# Service Bulletin

Bulletin No.: 09-07-30-004J

**Subject:** Slips in Reverse or Third, Delayed Reverse or Drive Engagement, DTC P0776, P2715, P2723, Harsh 2-3 Shifts (Inspect 1-2-3-4 / 3-5-R Housing and Pump Seal Rings)

**Models:** 2006-2009 Cadillac STS-V, XLR, XLR-V  
2007-2008 Cadillac Escalade, Escalade ESV, Escalade EXT  
2006-2009 Chevrolet Corvette  
2007-2008 Chevrolet Silverado  
2008 Chevrolet Suburban  
2007-2008 GMC Sierra, Sierra Denali, Yukon Denali, Yukon XL Denali  
2008 GMC Yukon XL  
2008-2009 HUMMER H2  
2008-2009 Pontiac G8  
Equipped with 6L80 or 6L90 Automatic Transmission (RPOs MYC, MYD)

2715381

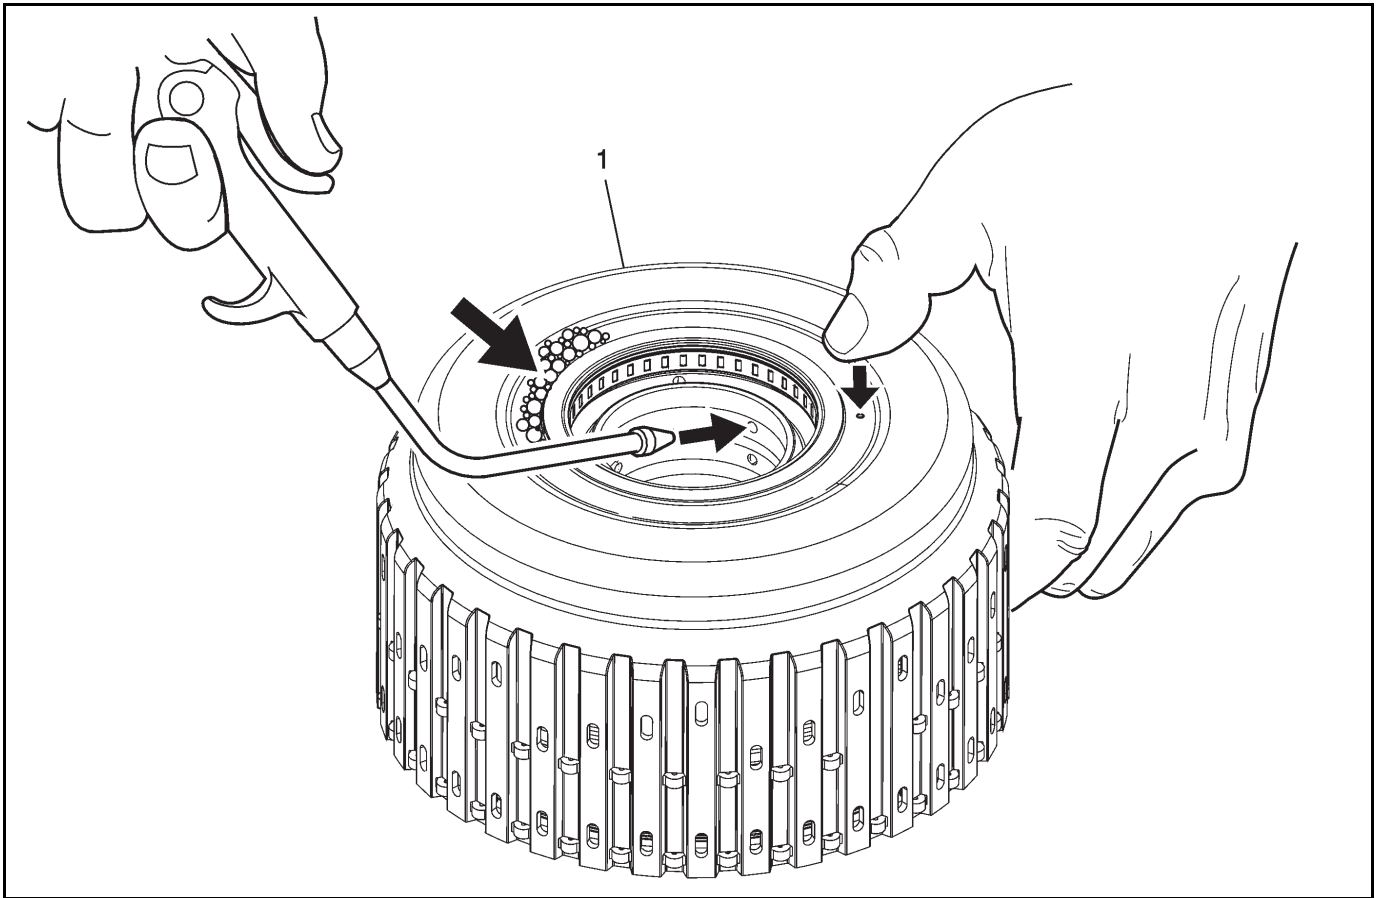
Inspect the 1-2-3-4 / 3-5-R clutch housing for a possible cracked weld. The housing can be inspected either assembled or disassembled.

1. Apply soap compound to the weld area of the housing.
2. Hold your thumb over the air bleed passage.
3. For a fully assembled 1-2-3-4 and 3-5 reverse clutch housing, spray compressed air into the 3-5R clutch feed hole and inspect the weld area for bubbles.
4. If bubbles are detected, a new housing is required.

2539550

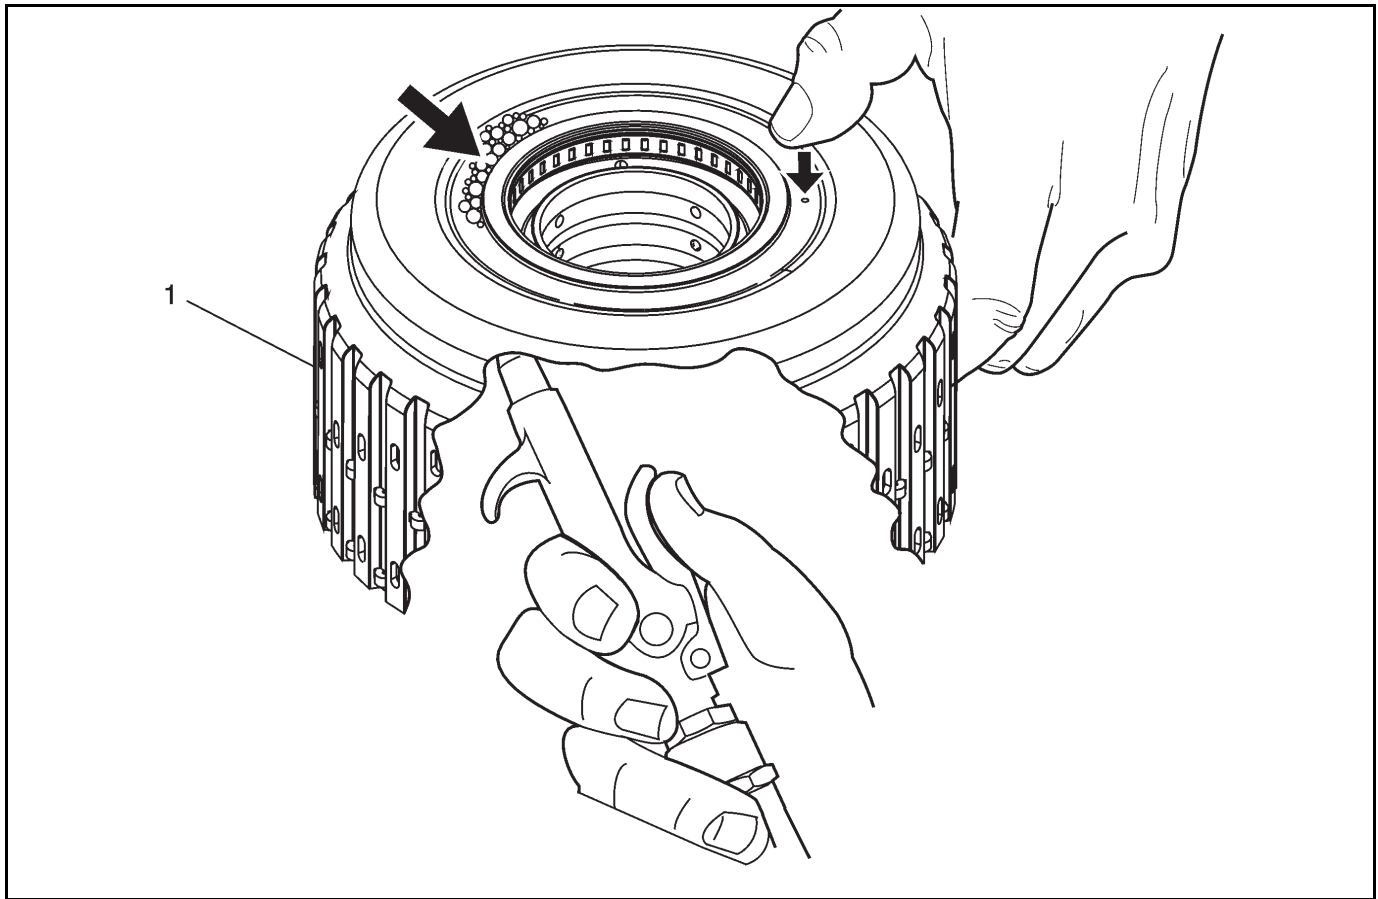
Inspect the 1-2-3-4 / 3-5-R clutch housing for a possible cracked weld.

1. Apply soap compound to weld area of the housing.
2. Hold your thumb over the air bleed passage.
3. Spray compressed air into the housing and inspect the weld area for bubbles.
4. If bubbles are detected, a new housing is required.

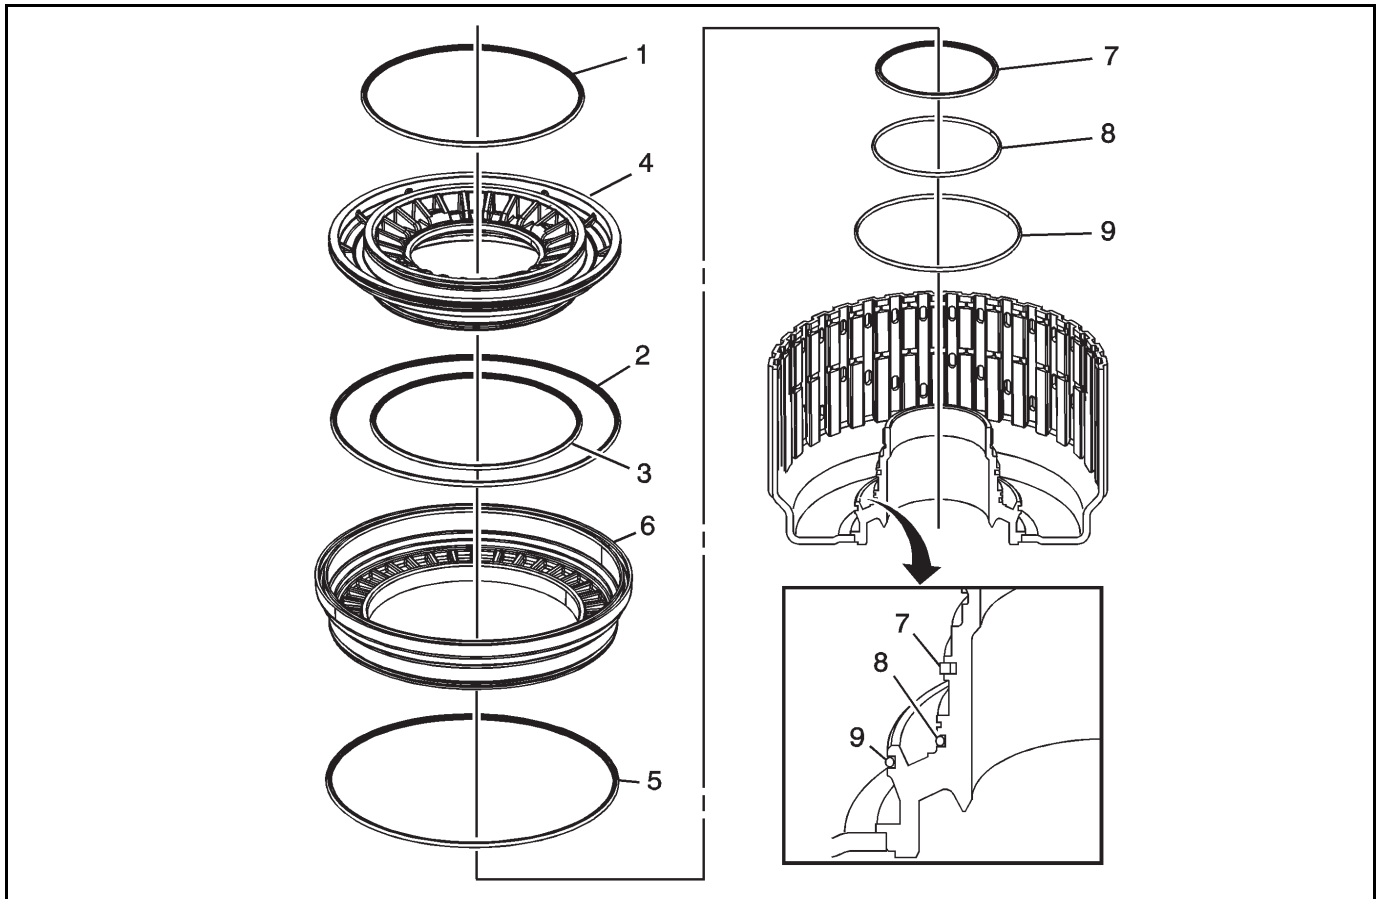
**Important:** When installing a new 1-2-3-4 / 3-5-R housing into a 2007 or older 6L80, be sure to install all three (3) inner seals (7, 8, 9 in illustration below). Failure to install these seals can result in no reverse, no forward or distressed clutches.

2219005

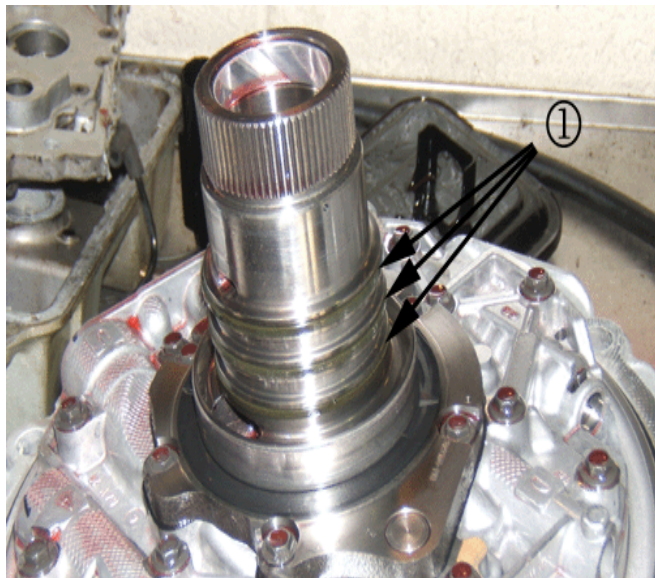
A harsh 2-3 shift condition may be caused by leaking 1-2-3-4 and 3-5-R clutch fluid seal rings (1) on the transmission fluid pump cover assembly.

1555367

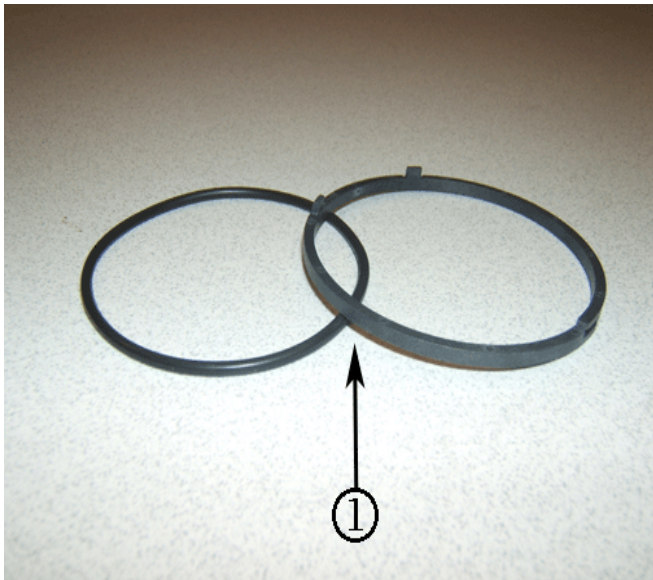
Inspect the fluid seal rings. Transmissions in 2006, 2007, 2008 and early build 2009 models used a 1- piece design seal ring in production. Starting December 2008, a 2-piece seal ring design was implemented. The 1-piece seal ring design may cause a harsh 2-3 shift due to leakage. This is typically a low mileage issue. If the seal rings are a 1-piece design they should be replaced with new 1-piece design seal rings. It is not necessary to replace the pump cover.

**Notice:** The clutch fluid seal rings must be installed in a specific way. Failure to install new clutch fluid seal rings in the proper orientation may cause a repeat harsh 2-3 shift. Refer to 1-2-3-4 and 3-5 Reverse Clutch Fluid Seal Ring Installation (6L80/90) in SI for correct installation.
